Reply to anonymous Reviewer #1

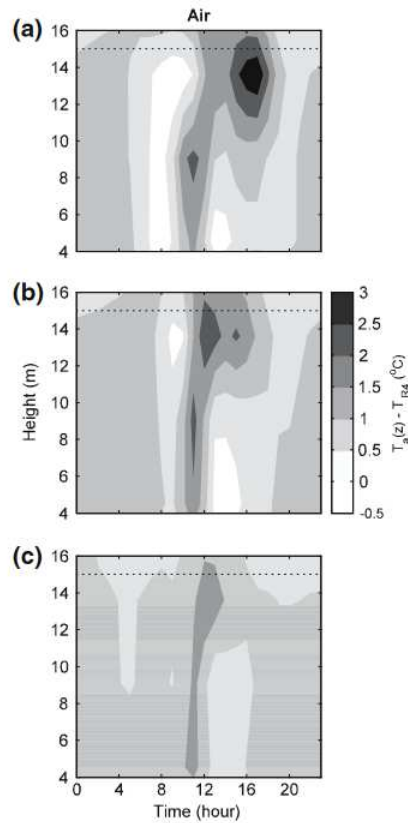
RC1.4: In the Theory section, one particular sentence that struck me as odd was in line 220-222, mentioning that VPD is highly influential on ET, is height-dependent on wind speed, but that would require CFD or local measurements so the authors just omit it...? I find it hard to justify this choice given that the authors explicitly state its importance on ET only to then ignore the variations.

With this criticism both reviewers are right! We agree that this paragraph needs clarification and will be revised. Of course, VPD has a high impact on ET (as shown in Figure 3), high variations of VPD lead to high variations of ET. However, the temperature differences at one point of the facade in the diurnal course are much higher than the differences in the height profile, as shown in Offerle et al. (2007), see the figure below. A height dependency is only visible for short periods. Therefore, we discuss that the impact of the height profile compared to a uniform VPD is neglectable.

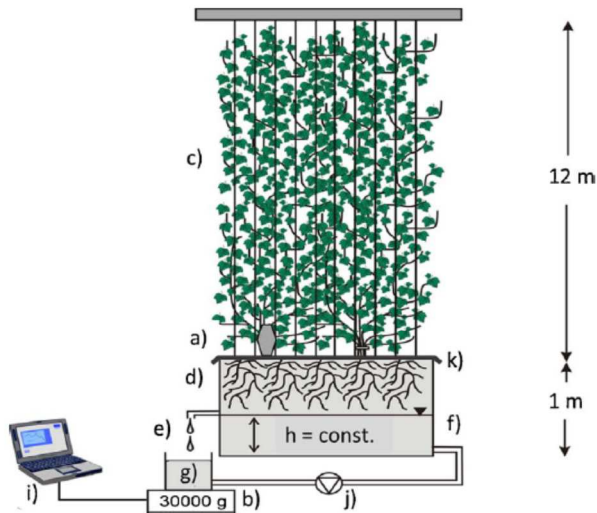
RC1.5: The Material/Methods section then feels lacking in some details: the scientific quality of the article would benefit some more detailed description or visualization of the measurement setups (both at the experimental site and the external measurement sites). Especially the location of the sensors at the experimental site are important, given the strong non-linearity of environmental properties in the urban area, with wind speed as the most obvious one. The authors very briefly touch upon wind influence but seem to conclude that it is not important for ET estimation - this might also have to do with the location of the wind measurements and the behaviour of the wind at its microclimate.

It is a bit difficult to discuss feelings. From our point of view, the M&M was complete with the reference to Hoelscher et al. (2018), where the setup is described in detail. However, we took your comment serious and as an occasion to re-write the M&M section in a way, that the article is self-explaining. We will add a technical drawing of the measuring setup, a re-draw of the figure 1 from Hölscher et al., 2018 and we will combine it with a technical detail drawing of the water consumption measurements mentioned above.
